SUMMARY OF AMENDMENT

PHASE 120-A: MODIFIES SITE DESIGN CRITERIA CONCERNING NO LEFT TURN SIGNS AND TRAFFIC LANES UNDER SECTION 5, INGRESS AND EGRESS, UPDATES CRITERIA TO CONFORM TO RECENTLY ADOPTED ZONING REGULATIONS, AND CHANGES PARKING SPACE SIZE TO BE IN ACCORDANCE WITH THE LATEST ZONING REGULATIONS.

VILLAGE OF OAKLAND MILLS  
THUNDER HILL  
SECTION 3 AREA 2  
PETITIONER AND OWNER

AMENDED  
FINAL DEVELOPMENT PLAN PHASE ONE HUNDRED TWENTY-A  
6TH ELECTION DISTRICT HOWARD COUNTY, MD.  
SCALE 1" = 400'  
SHEET 1 OF 6

**SITE DESIGN CRITERIA**

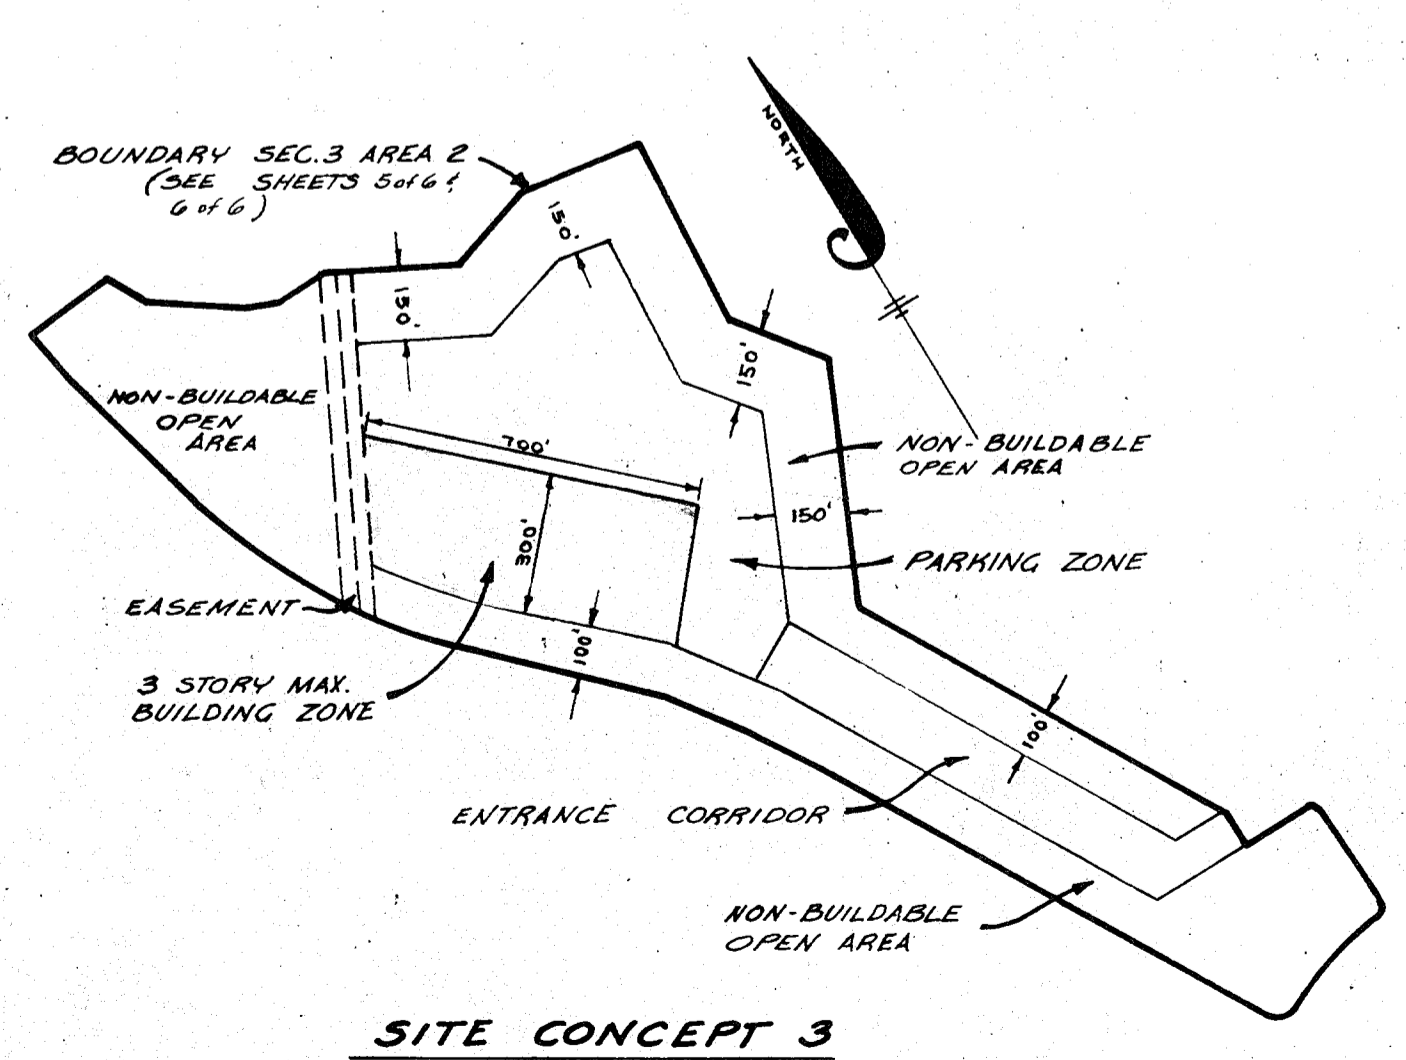
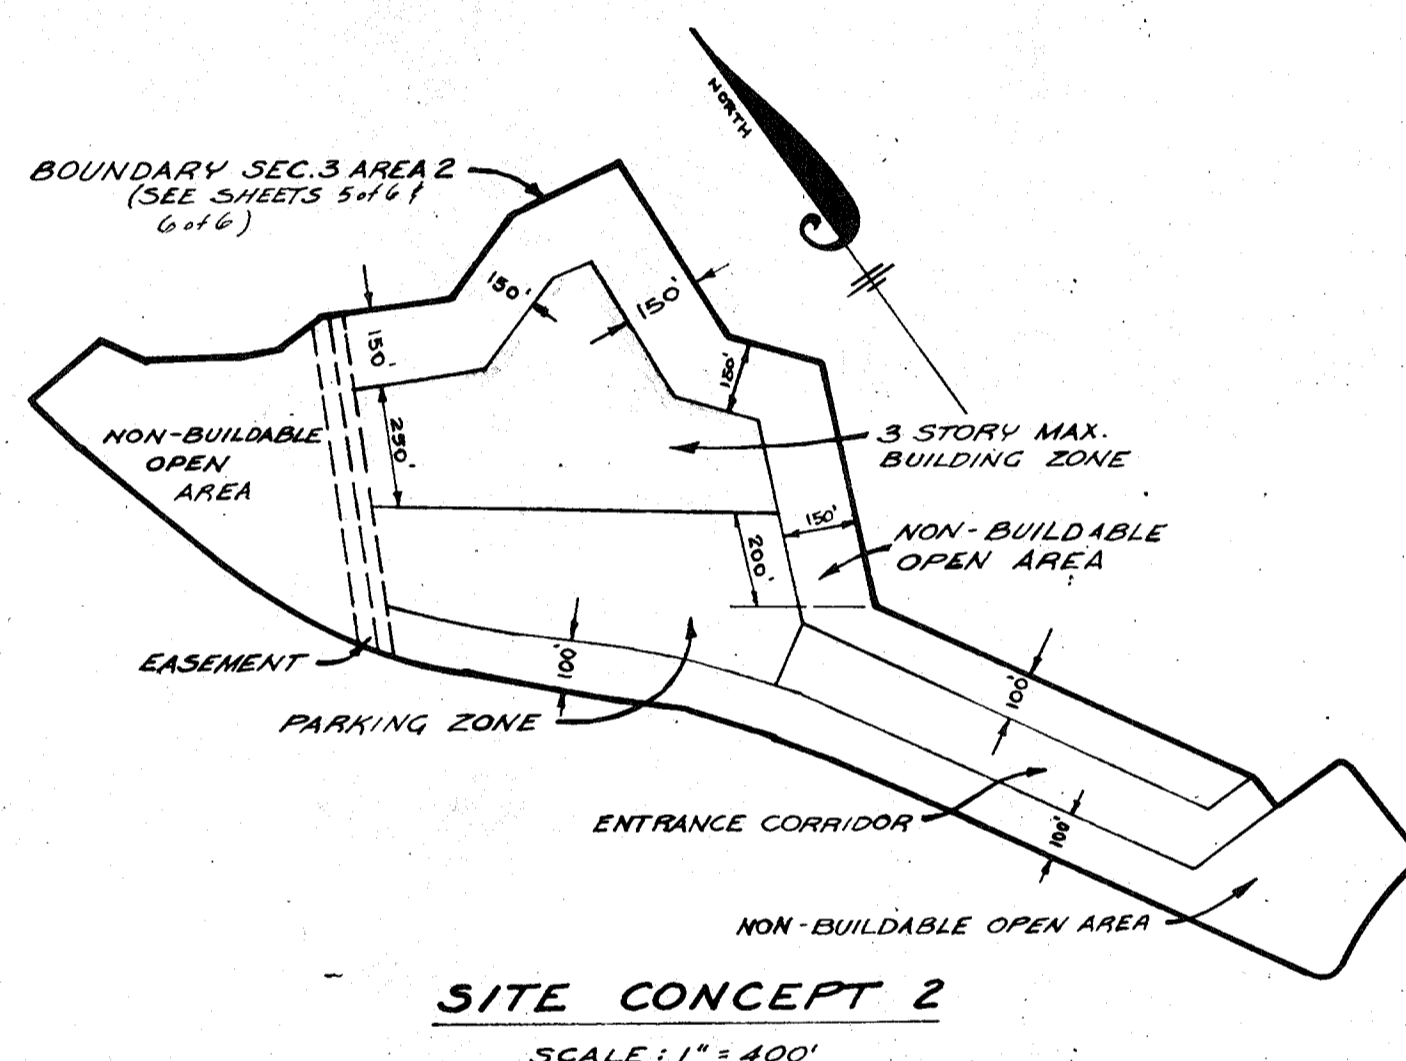
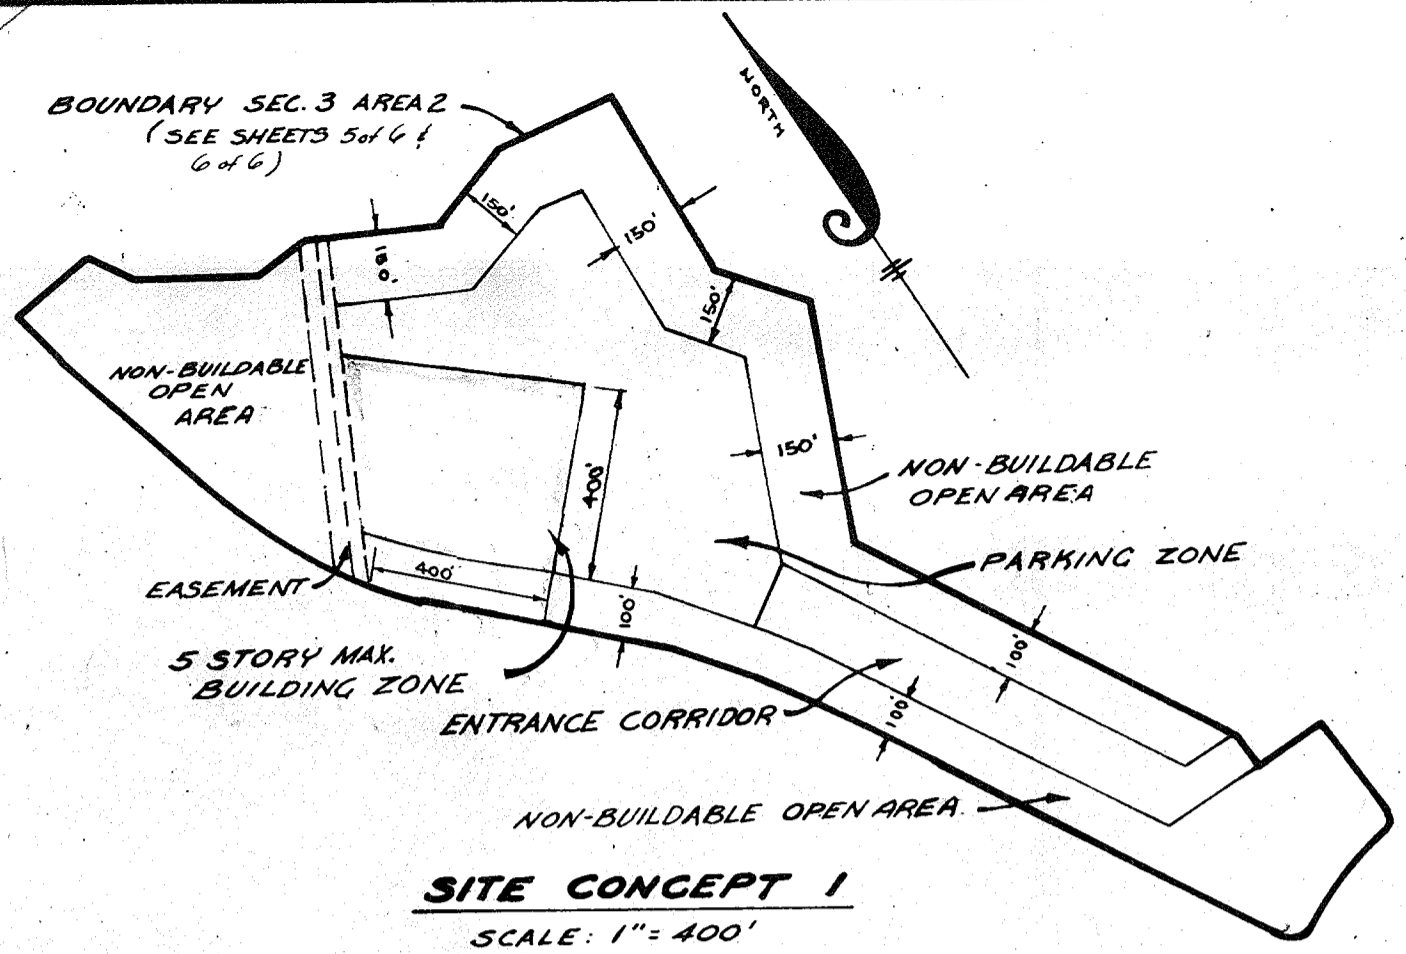
NOTE: The purpose of this amended Final Development Plan which supersedes Phase 120 recorded among the land records of Howard County, Maryland in Plat Book 20, Folio 224 on May 18, 1973 is to modify site design criteria, no left turn signs under Section 5 ingress and egress.

- a. "No left turn" signs shall be posted on Lime Banks Way at the intersection with Lightning View Road as determined by the Department of Public Works.
- b. An additional traffic lane shall be constructed between Lime Banks Way and Md. Rte. 175, if and to the extent determined by the Department of Public Works.
- c. A circulation pattern for construction traffic shall be approved by the Howard County Office of Planning and Zoning prior to approval of the site development plan.
- d. Md. Rte. 175 shall be open to traffic between I-95 and U.S.Rte.29 prior to occupancy of any building within Phase 120.
